## Technical Note

Project	317 Finchley Road
Title	Planning Note to Support S73 Application
Ref.	240
Rev.	C
Date	05.04.24

The purpose of this Technical Note is to provide technical guidance regarding a material amendment to the consented scheme (Planning Ref. 2016/2910/P) The proposal looks to replace the following drawings:

Fig. 4 Proposed façade detail section

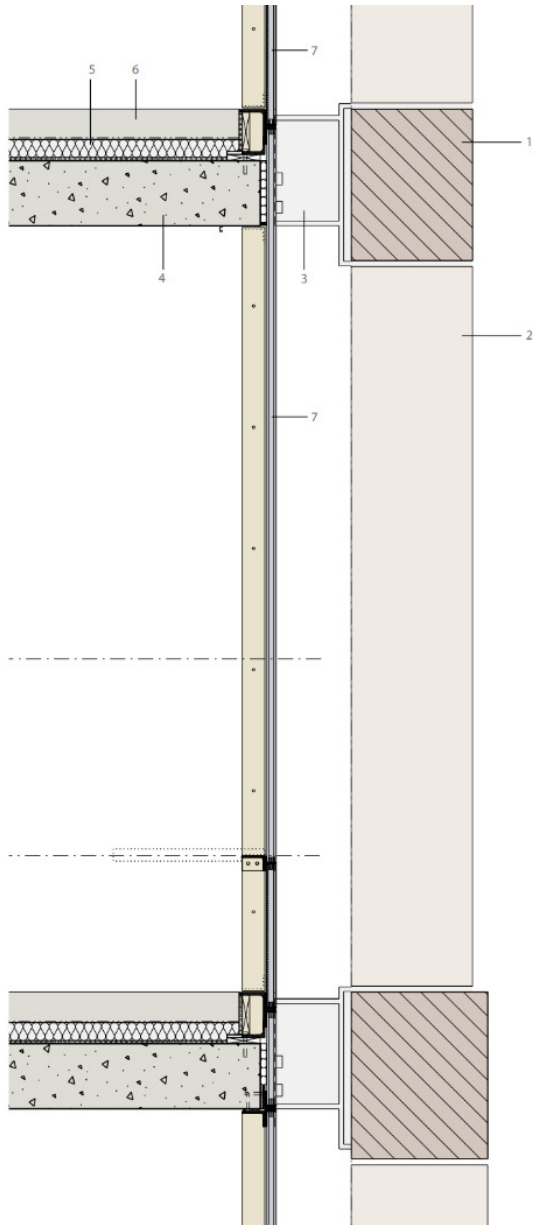
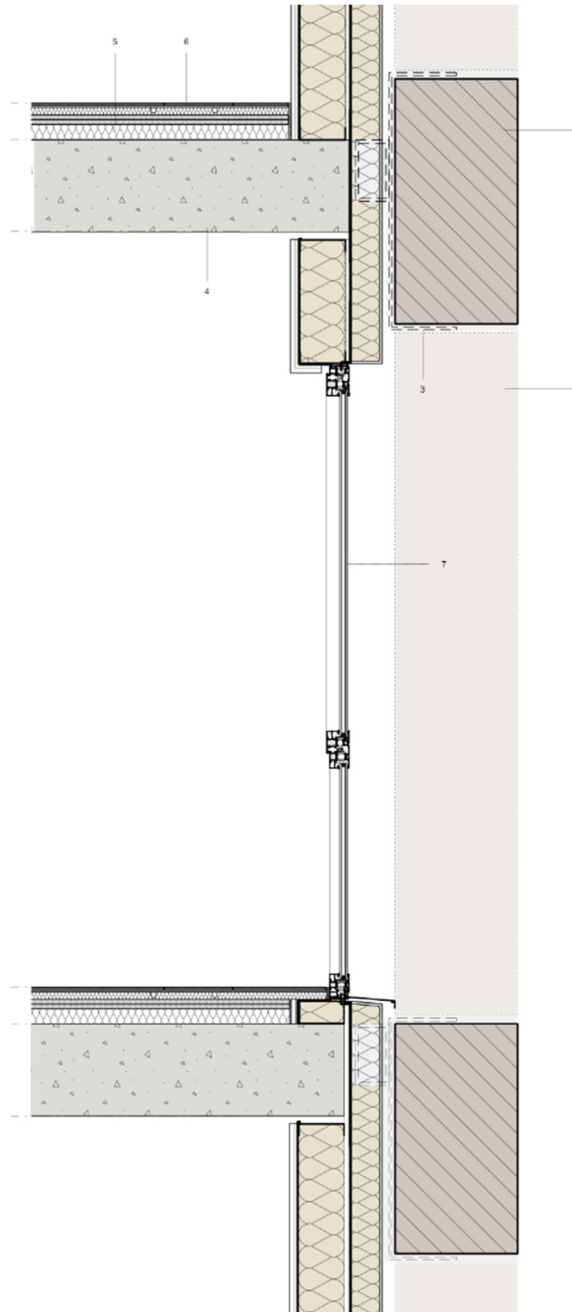
1.2 The proposed external wall system, as seen in fig. 4 below, provides a more robust and durable exterior than the previously approved scheme in fig. 3.

Fig. 6 Proposed Lower Ground floor plan

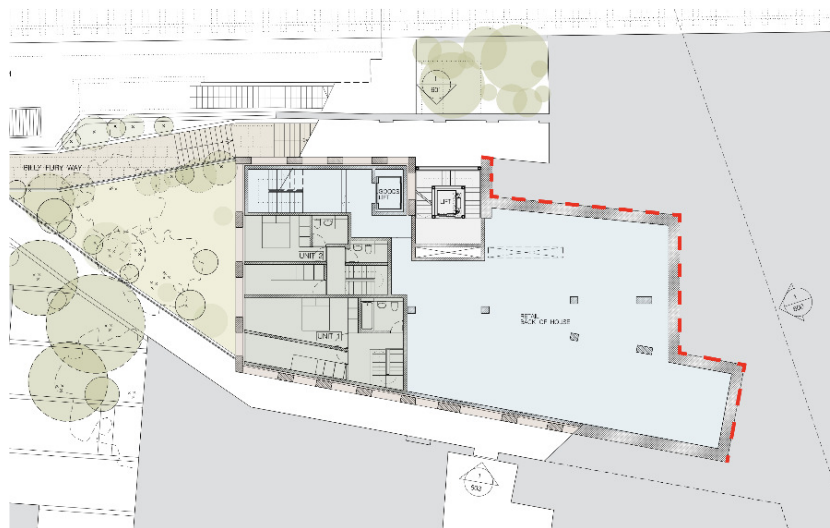
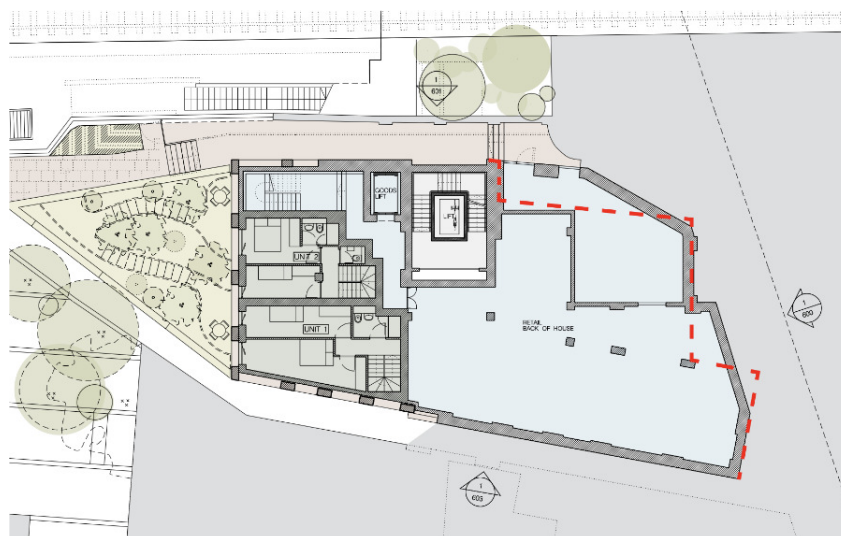
2.1 Development in the scheme's structural performance has enabled us to adjust the basement plan and lower ground plan footprint along the east side as seen highlighted in fig. 5 and fig. 6. With the implementation of the UKPN substation used to distribute electrics throughout the local area, the amended footprint offers a preferable place to store and access the substation safely. Please see the Basement impact assessment J2680-S-RP-0004\_02\_S9 Basement Impact Assessment submitted alongside this Technical note for further details on the effect this adjustment has on its surroundings.

Fig. 8 Proposed Billy Fury Way stair

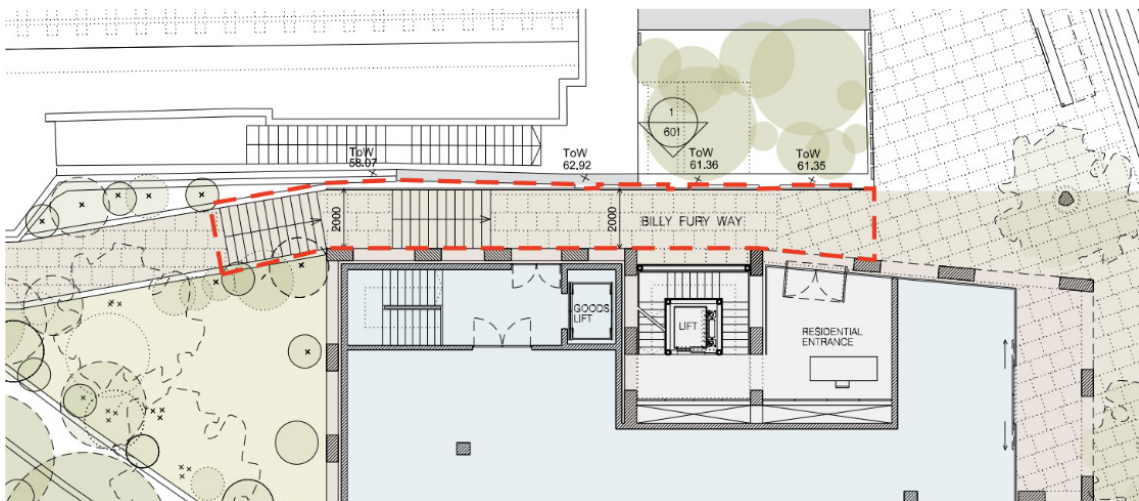
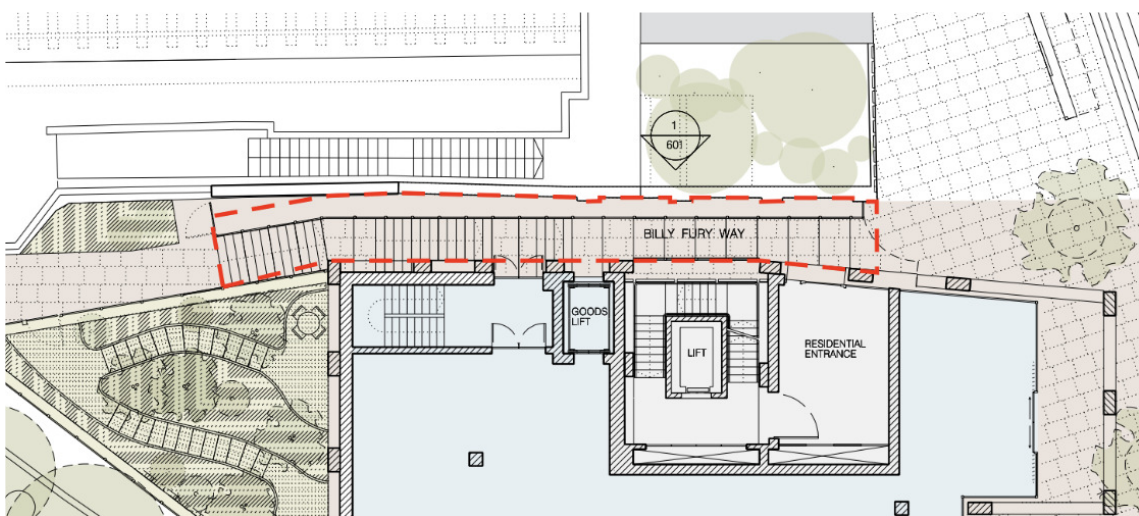
3.1 The Billy Fury Way staircase has been adjusted to minimise the impact on the wall to the north of the site which is shared with the train station. To achieve this the proposed Billy Fury Way stair will be fixed and supported from the proposed reinforced concrete walls of the Lower ground and sits independent of any existing structures. This proposal provides access to the UKPN substation within regulations. The proposed stair has minimal effect on the previously approved scheme by maintaining the same finishing tile as the surrounding area and the previously approved stair. This can be seen below in figs 7 and 8.

Fig. 9 Proposed ground floor emergency access arrangement to Billy Fury Way.

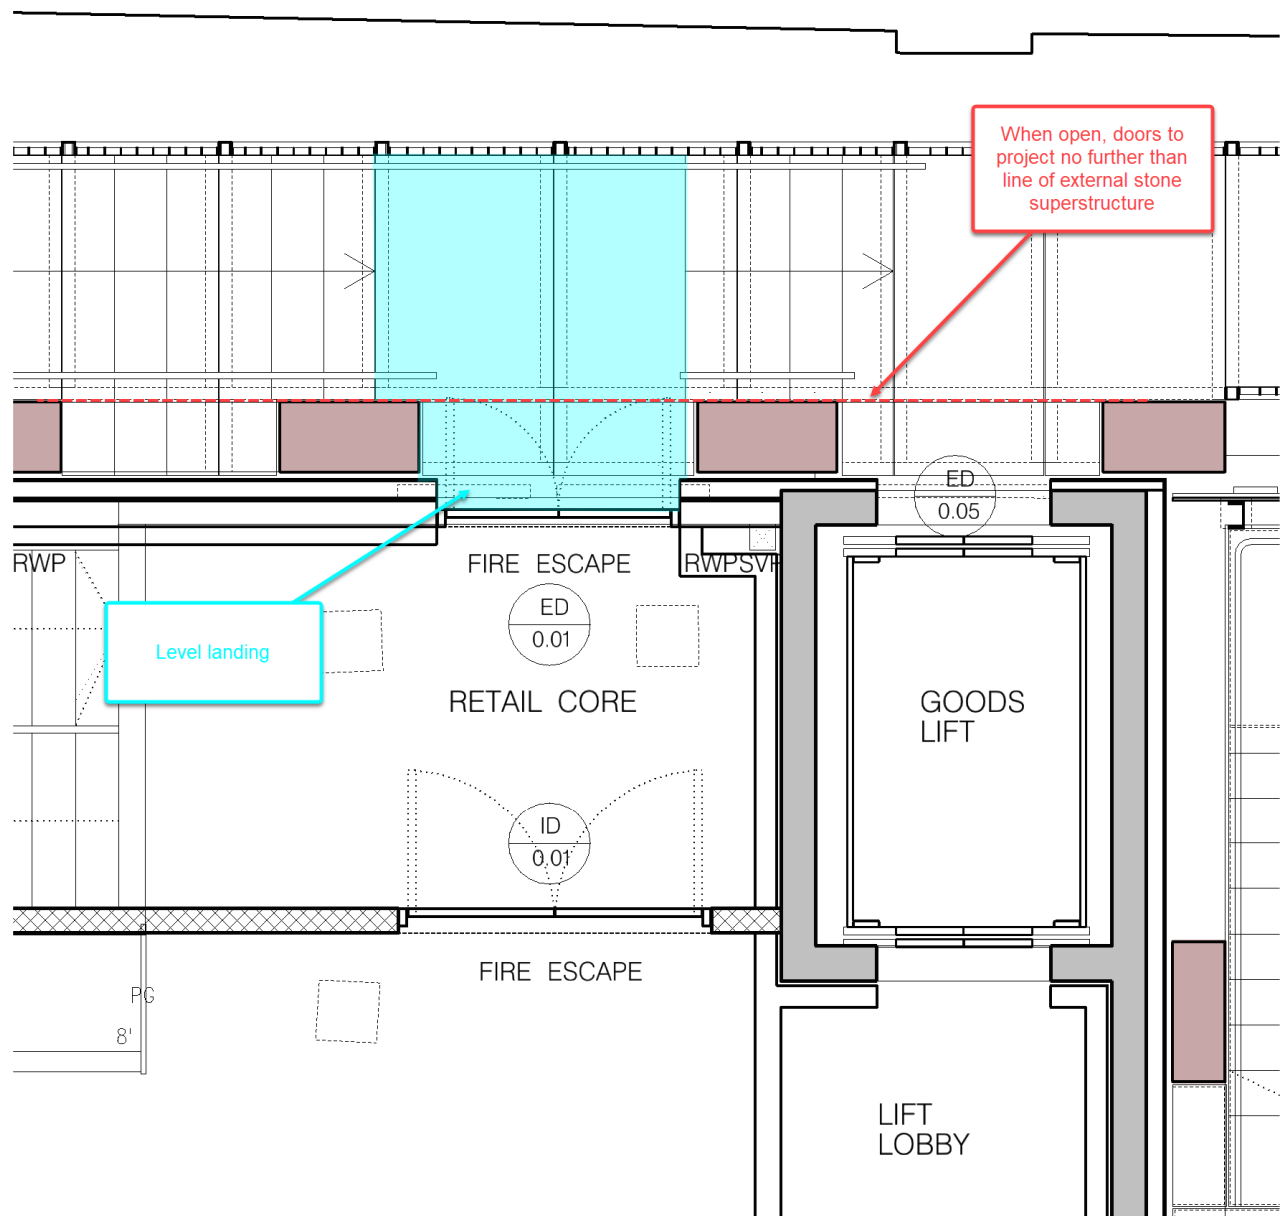
3.2 The externally opening emergency escape doors will be positioned to ensure when open they project no further than the external face of the stone superstructure to avoid causing harm to pedestrians walking past.

Fig. 11 Proposed slanted stone columns.

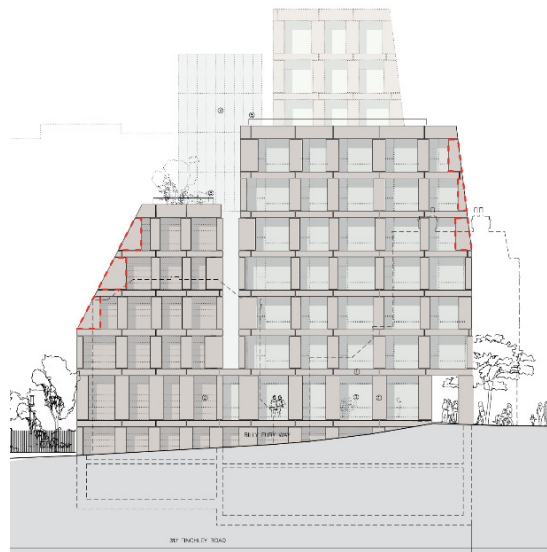
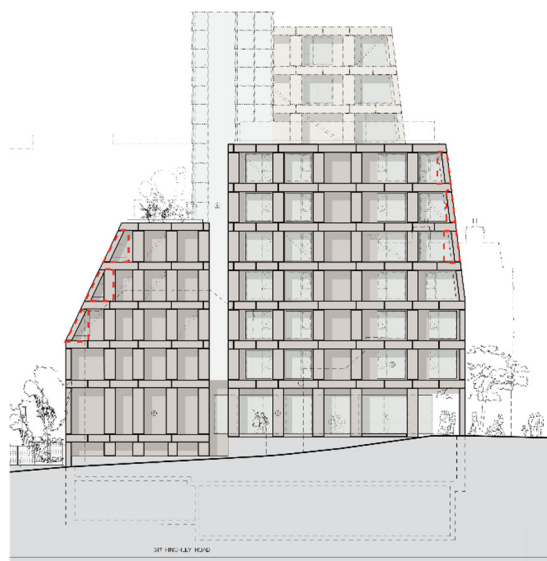
4.1 Minor refinements to stone column and lintel dimensions are proposed as part of the minor material amendment. The slanted stone columns as highlighted in fig. 11 are proposed in a similar geometry to the column and lintels across the planning approved scheme in fig. 10. This simplifies the installation on site and the manufacturing process resulting in less material wastage.

Fig. 13 Proposed stair core glazing composition

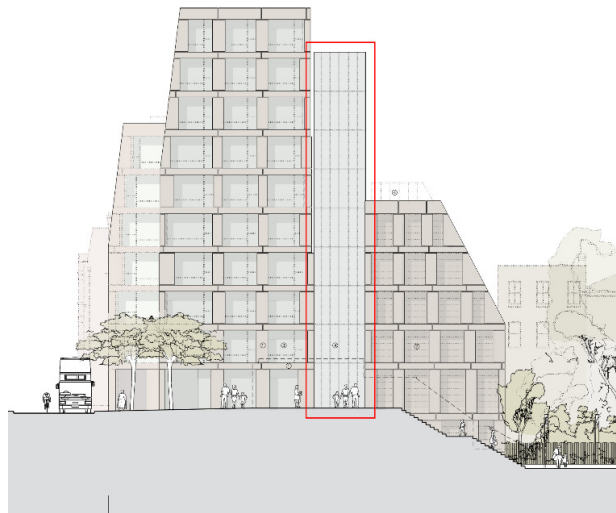
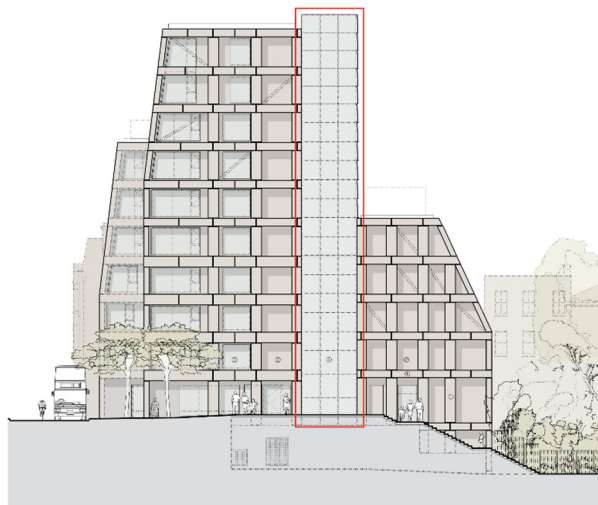
5.1 The composition of glazing has been altered on the stair-core to follow similar proportions of the glazing throughout the rest of the planning approved scheme, forming a more cohesive design. The stair core glazed facade is stepped and lapped to allow natural through-ventilation. Single glazed panel raised to form balustrade to the staircase roof for maintenance and access to the smoke ventilation equipment installed to meet current fire regulations.

Fig. 14 Proposed structural steel bracing elevation

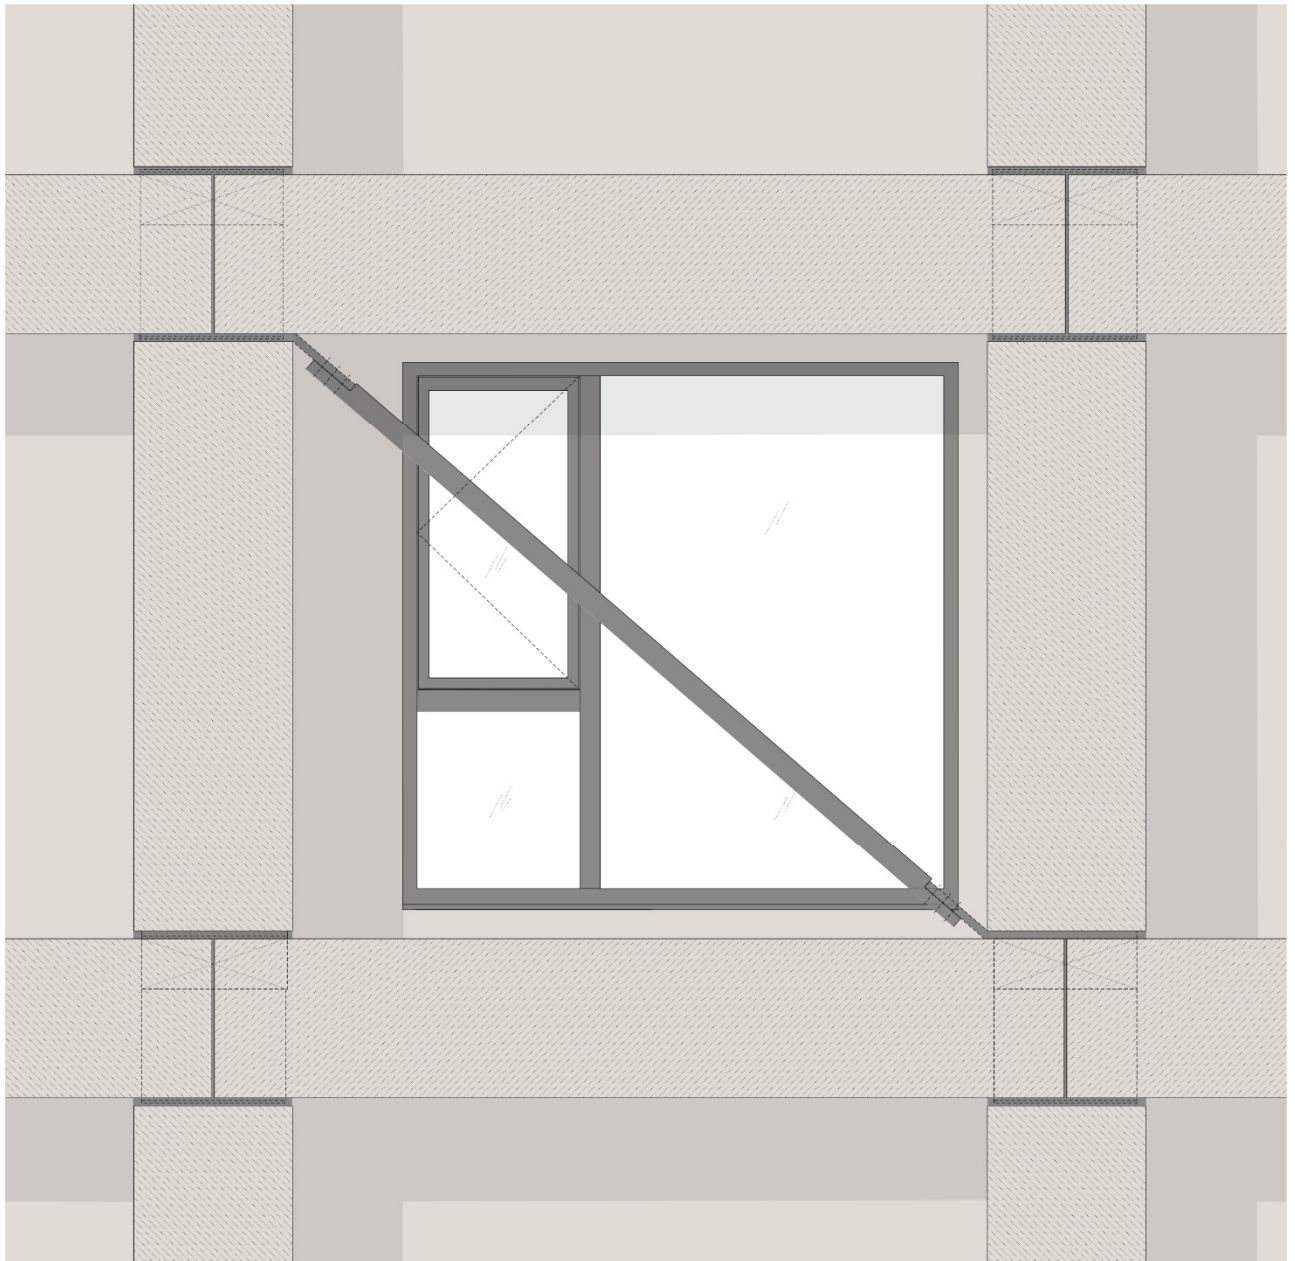
6.1 By introducing occasional steel bracings we've been enabled further refinement in the stone exoskeleton. This enables the slimming of stone columns and further emphasises the planning approved scheme of expressing the structure externally. The bracings will be colour matched to surrounding metalwork. The minimal impact of the steel bracings can be seen in fig. 14.

Fig. 16 Proposed typical floor plan

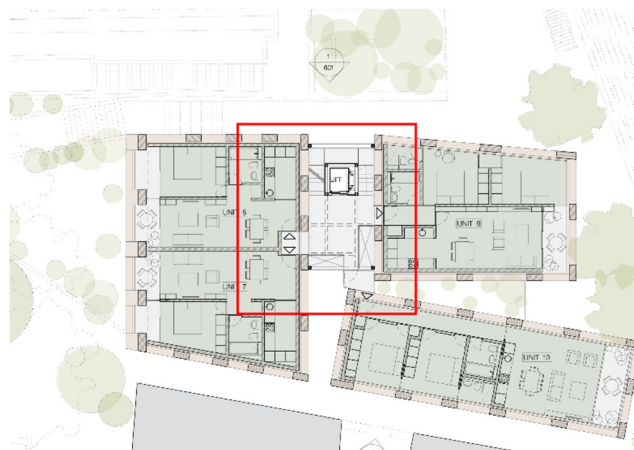
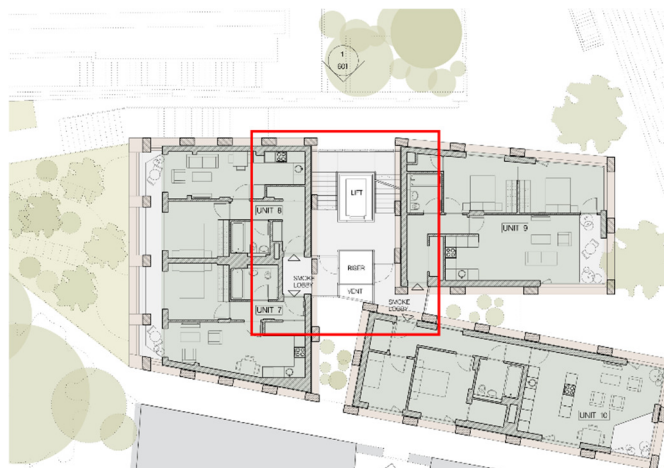
7.1 Further to LFB consultation request have been made to upgrade the scheme to meet current fire regulations. Summary below of changes which have been introduced, please read in conjunction to Hydrock Fire Strategy/ Technical note:

- Mechanical smoke ventilation shaft incorporated with minimum 0.6m<sup>2</sup> free area and AOV within each lobby.
- Smoke lobbies to all floors incorporated to separate/protect the main stair from the apartments.
- Plant associated with the smoke ventilation + generator have been located on the main staircore roof.
- Sprinklers and LD1 detection introduced to all apartments.
